Agenda Item 6

Planning Committee Date Report to	6 th November 2024 Cambridge City Council Planning Committee
Lead Officer	Joint Director of Planning and Economic Development
Reference	24/01588/FUL
Site	Nos. 16-17 and 18-19 Sidney Street, and No. 21 Hobson Street, Cambridge, CB2 3HG
Ward / Parish	Market
Proposal	Demolition of existing buildings except for nos. 16 and 17 and 18 - 19 Sidney Street facades, and no. 16-17 street facing roof aspect and chimneys, for the provision of: Replacement retail units totalling 882m ² (use class E (a) (b) (c) & (e)); 4,107m ² of office space (use class E (g) (i), (ii)); 349m ² of community space (use classes F1 and F2); a new shopfront to no.16-17 Sidney Street and alterations to roof and northern chimney, and public realm enhancement works.
Applicant Presenting Officer	Mr Richer Dean Scrivener
Reason Reported to Committee	The application involves the demolition of a designated Building of Local Interest (No. 21 Hobson Street)

Proposed Ground Floor Plan

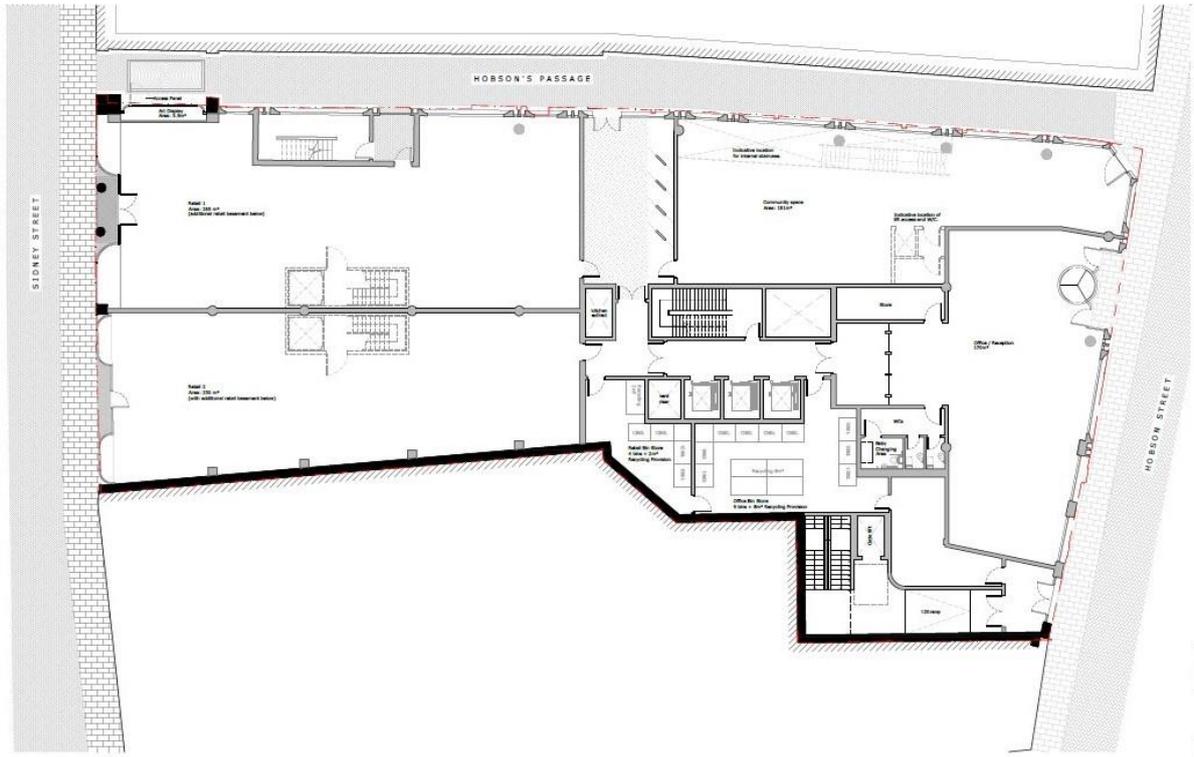
The Panel does however suggest that the design team should consider flipping the accesses to the bin store and office cycle parking, so that the office entrance is not adjacent to the bin store access. It would be more appropriate for the office cycle parking access to be adjacent to the office entrance; the office employees arriving by bike seem to be underserved, when compared with the space provided in the office lobby area - the two elements are not in quite the right balance at present.

While electric scooter charging has been mentioned, the Panel notes that the design team has yet to consider the same for cycles; overall, efforts should be made to maximise the number of charging points in all of the cycle/ scooter storage areas.

In looking at the refuse strategy, the Panel recommends reassessing the design/ width of the corridor that is the same route as for cycles -there is a potential contamination issue with the current arrangements. A refuse collection strategy is needed, one that make clear where bins will be put on Hobson Street.
